Letter of Transmittal No. 0008

PROJECT: Webster University Interdisciplinary Science Building

RE: Steel Reinforcing Shop Drawings - Level
01 Walls

Subject: 03 3000 Cast-In-Place Concrete –
Steel Reinforcing Shop Drawings –
Level 01 Walls

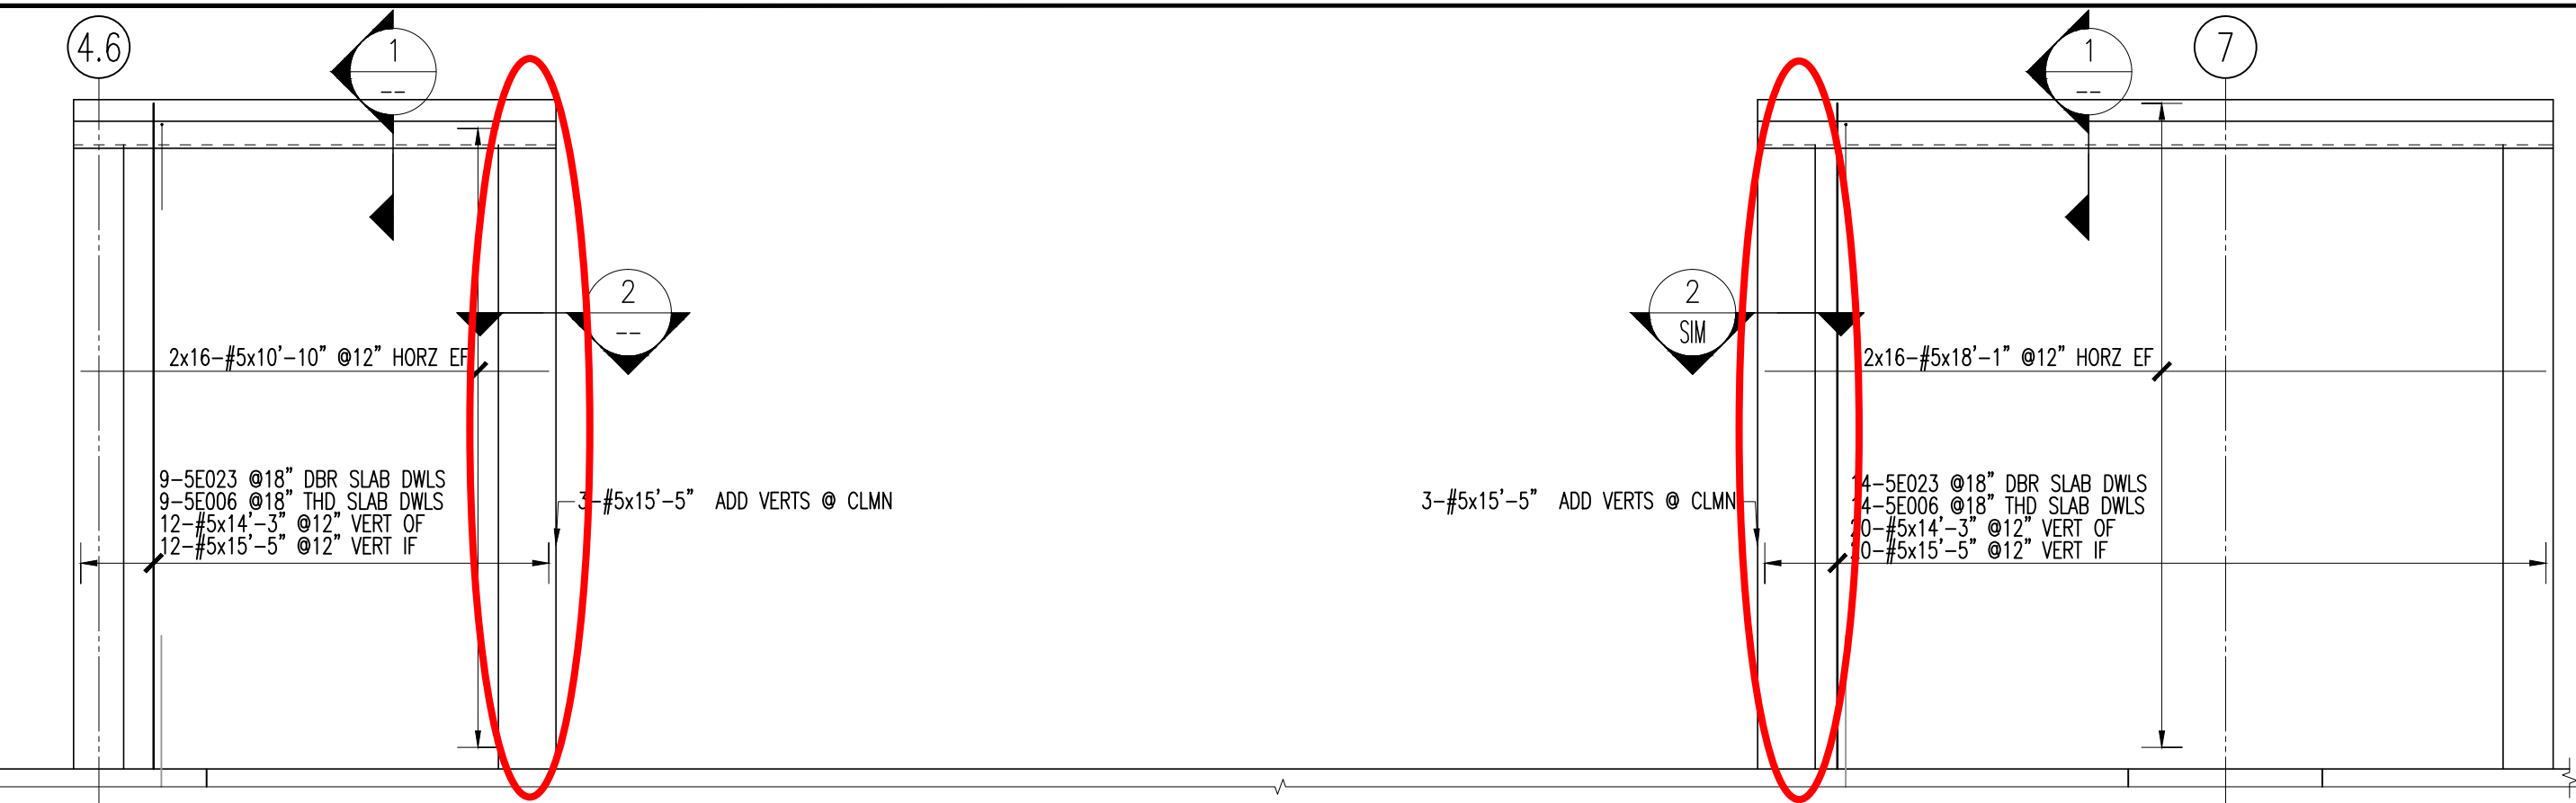
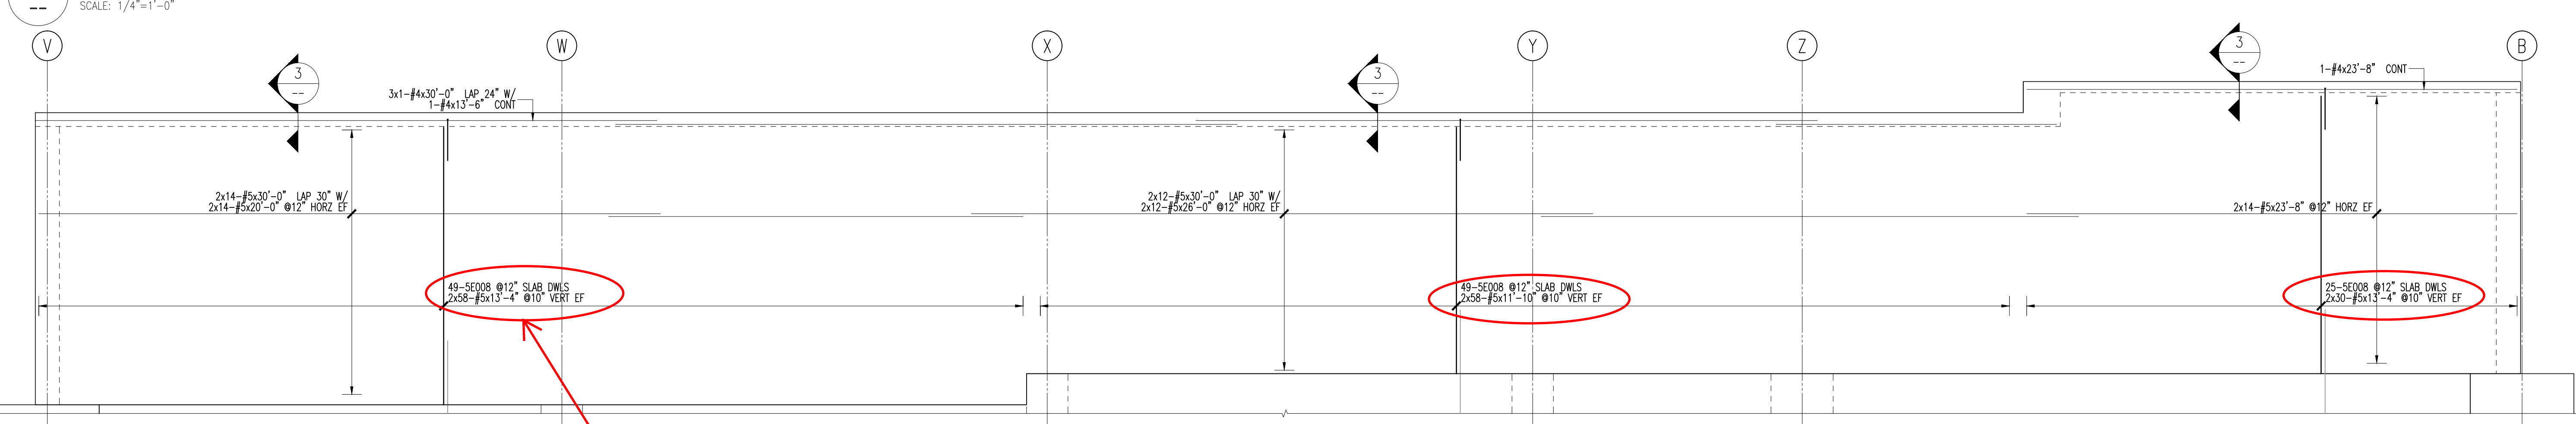
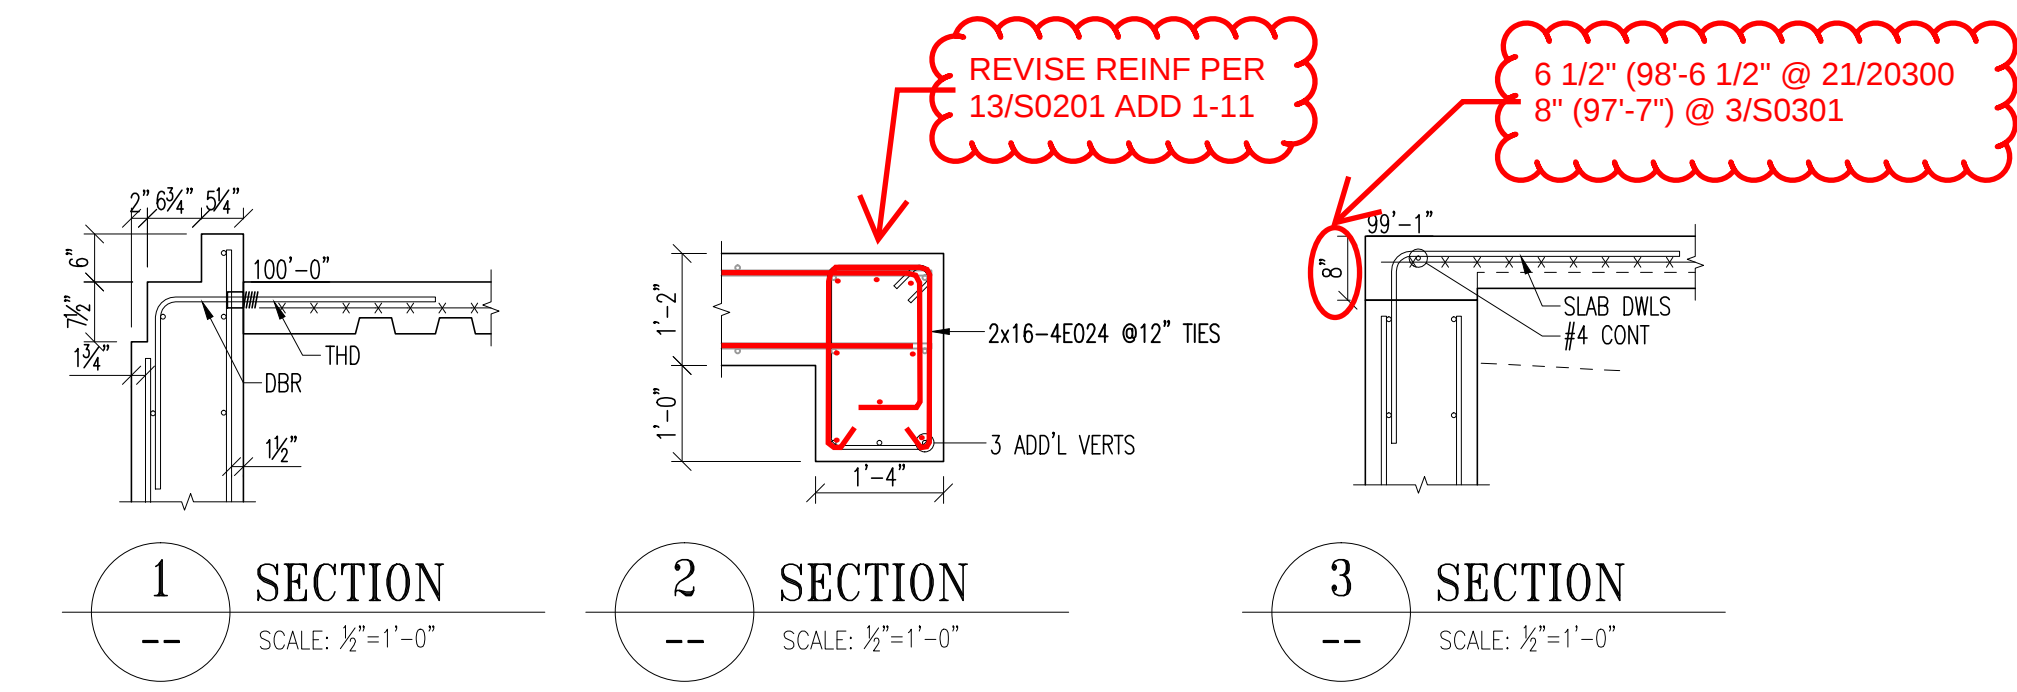
#4 DWLS @ 12"oc
#5 @ 10"oc OF
#6 @ 10"oc IF
REVISE WALL
TYPICAL
